File Number:	Roll Number:
Location of Property: <i>635 Douro 8th Line</i>	
Owner (s) Name: <i>John Coughlin</i>	
Phone Number: <i>705-931-0929</i>

**Severed**

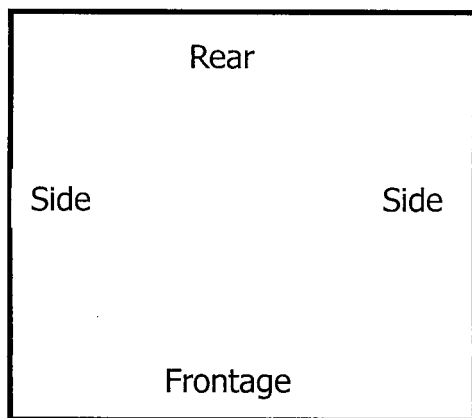
Street/Road Name:	<i>Douro 8th Line</i>	
Safe Entrance Possible:	Yes <input checked="" type="checkbox"/>	No <input type="checkbox"/>
Culvert Required when lot developed:	Yes <input checked="" type="checkbox"/>	No <input type="checkbox"/>
3 metre strip of frontage from severed parcel required:	Yes <input checked="" type="checkbox"/>	No <input type="checkbox"/>
Other Requirements (i.e. fill, brushing, etc.):

**Additional Comments:** *Minor brushing to achieve site lines - Minor ditching for drainage.*

**Severed**

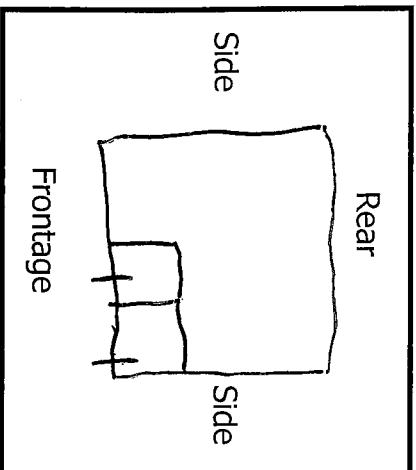
Street/Road Name:	<i>Douro 8th Line</i>
Safe Entrance Possible:	Yes <input checked="" type="checkbox"/> No <input type="checkbox"/>
Culvert Required when lot developed:	Yes <input checked="" type="checkbox"/> No <input type="checkbox"/>
3 metre strip of frontage from severed parcel required:	Yes <input checked="" type="checkbox"/> No <input type="checkbox"/>
Other Requirements (i.e. fill, brushing, etc.):

**Additional Comments:** *Minor brushing to achieve site lines - Minor ditching for drainage.*
